Job 23-5989-R01	Truss R08RP1	Truss Type Piggyback Base	Qty 5	Ply 1	LOT 0.0101 BLAKE POND   56 GREAT SMOKEY WAY LILLINGTON, NC
--------------------	-----------------	------------------------------	----------	----------	--

## REPAIR(S) REQUIRED

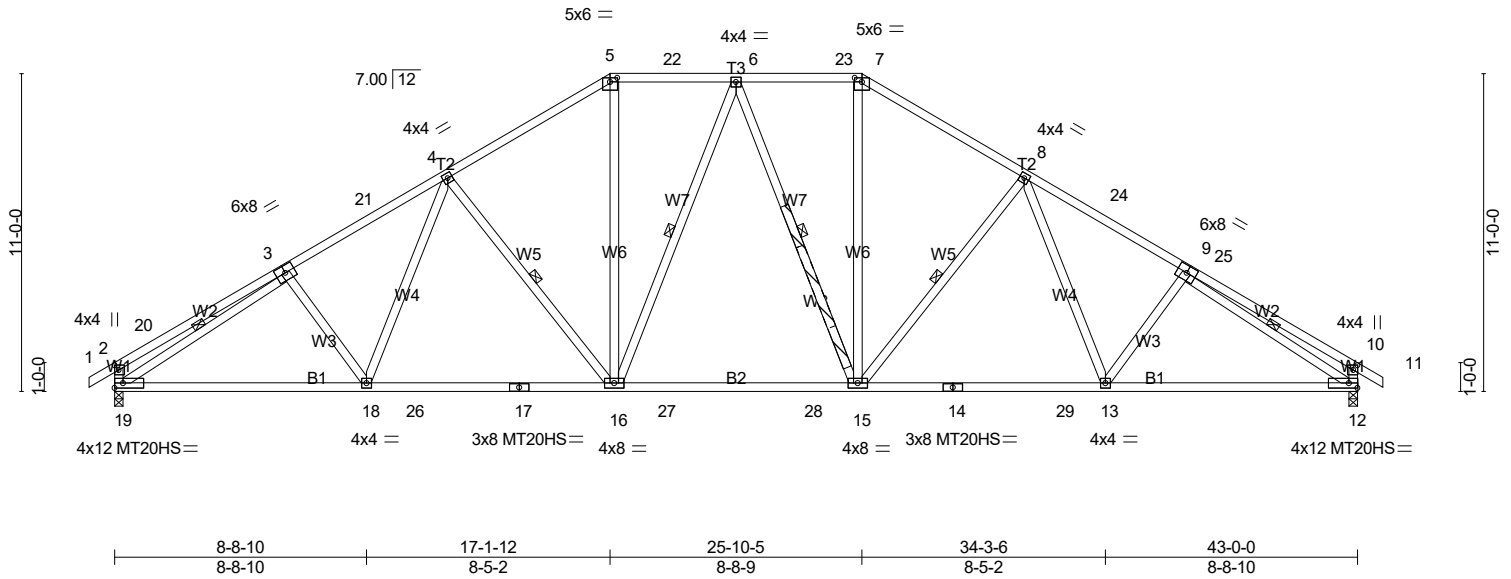
- 1) Repair Condition: web has damaged section 3-0-0 long starting 2-1-0 above joint 15.
- 2) Apply 72" long 2x4 SP No.2 scab to front side(s) of truss centered on damage located 3-7-0 above joint 15 with 2 row(s) of 10d (0.131"x3") nails spaced 2" o.c. from front face. Minimum 0-3-0 end distance.
